# Intel® 5000 Series Chipset Memory Controller Hub (MCH)

Specification Update

*May 2008*

Figure-1: Interrupt Swizzling

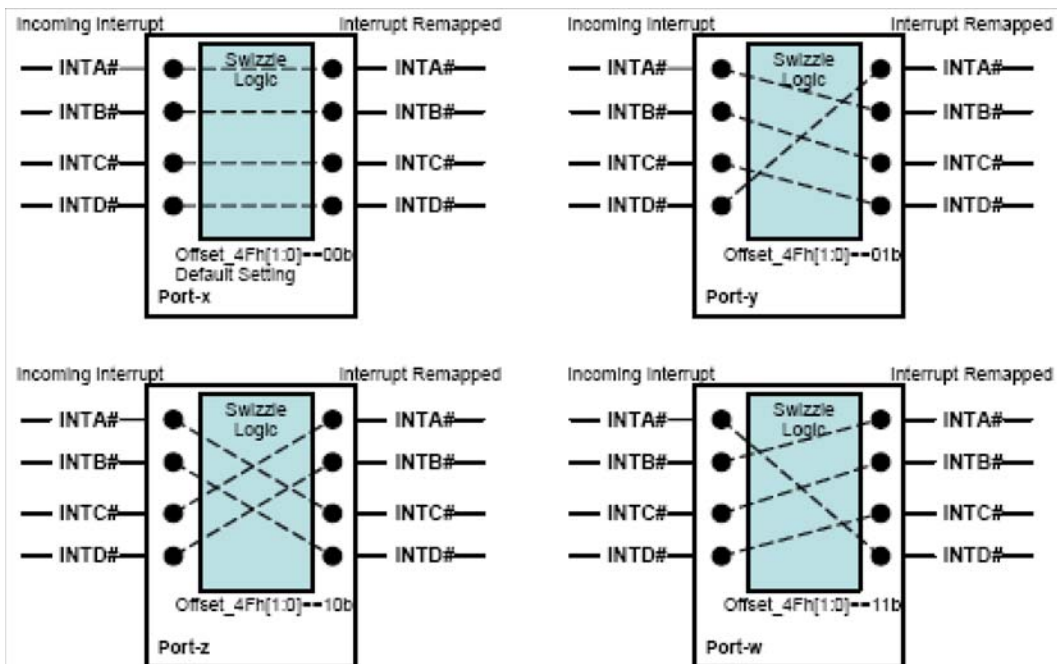
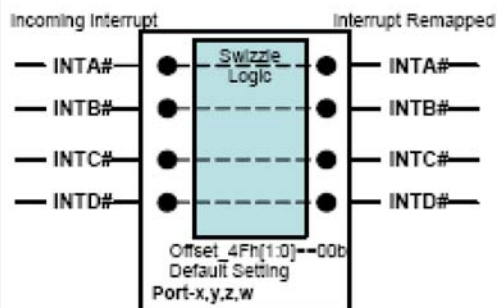
INTA (as depicted in Figure-2) is usually overloaded since it is reserved per the PCI/PCI Express spec for PCI/PCI Express devices (if the device uses interrupts), so is of particular concern. Figure-1 depicts interrupt swizzling where INTx is distributed. Figure-1 and Figure-2 depict an example of interrupt swizzling and should ONLY be used for illustration purposes, as system board interrupt routing is very platform specific.

For optimal system performance, it is recommended that system BIOS utilizes this register to achieve a more balanced PCIe interrupt distribution. Note that the PCI interrupt routing table in the system BIOS needs to be modified to match the particular swizzling scheme selected.
